Determination 2014/017

Regarding the compliance of three types of schist wall cladding systems proposed for future houses located in the Queenstown and Arrowtown areas

2.2.1 There are three types of schist cladding systems proposed as shown in Figure 1:

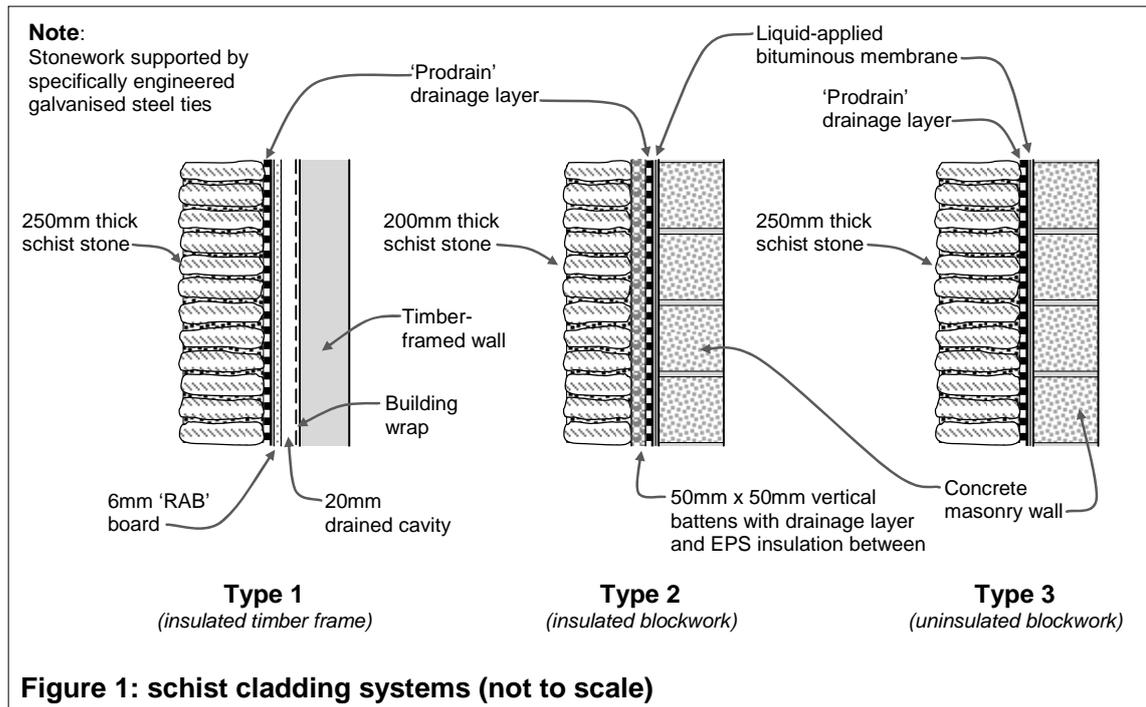
- 6.5.1 The expert noted that the authority had elected to compare schist cladding to the Acceptable Solutions for brick veneer. However, Type 1 cladding has a cavity of only 20mm, while Types 2 and 3 have no cavity.

- 6.5.2 The expert considered the compliance of the cladding systems with Clause B1 Structure. All three cladding systems incorporate 200-250mm thick schist that would weigh approximately 480-750kg/m². The expert noted this placed the veneer outside the scope of E2/AS1, NZS 3604, and the masonry veneer section of NZS 4229, which are limited to veneers with a mass of less than 220kg/m². Consequently specific engineering design was considered necessary in respect of:

- vertical loads, such as foundation and upper floor nibs etc
 - horizontal loads, such as design, spacing and fixing of ties
 - bracing design to accommodate the weight of the stone cladding

- the size and spacing of control joints
 - the mix and strength specified for the mortar.
- 6.5.3 The expert assessed the compliance of the cladding systems with Clause B2 Durability, noting that:

- ties for Type 2 are proposed to be fixed to battens, which are intended to be H3.2 treated, so ties should be either separated by DPC or be specified as stainless steel to prevent corrosion to the steel ties.

- The schist is installed against a backing board and a 20mm drained cavity separates the cladding from the timber framing.
- The 40mm cavity required for brick veneer arises from the need to allow for potential narrowing of the cavity by mortar and practical requirements of bricklaying; the backing sheets for Type 1 prevent such problems.
- Brick veneers are porous and the cavity design assumes that the back of the masonry may be wet. However, Type 1 incorporates a drainage layer over backing sheets to allow moisture to escape before reaching the cavity.

- A bituminous membrane is applied over the concrete block surface, with drainage sheets installed. The membrane and drainage layer are manufactured for high risk applications such as below-ground tanking.
- Although timber battens are fixed through the membrane, the drainage layer installed between battens will drain moisture away. Moisture would need to penetrate stone and the batten in order to reach the batten fixings.
- Given that the concrete block wall is not vulnerable to water damage, any rare minor leak would not be likely to result in a lack of adequate weathertightness.

6.6.4 In regard to Type 3, the expert noted that weather resistant elements are similar to those of Type 2 would also be expected to provide adequate weathertightness. (I also note that the lack of battens allows a continuous drainage layer over the continuous membrane weatherproof layer.)

- 7.1 The expert's report, the established service record of schist construction and the absence of any evidence to the contrary provide me with reasonable grounds to conclude that the proposed schist cladding systems will comply with the Building Code if appropriately documented and installed for each consent application in accordance with the criteria identified by the expert in paragraph 6.8.2.

- 8.1 In accordance with section 188 of the Building Act 2004, I hereby determine that the proposed schist wall cladding systems Type 1, Type 2 and Type 3 as described in this determination will comply with Clauses B1, B2 and E2 of the Building Code, if adequately documented for each future application for building consent.
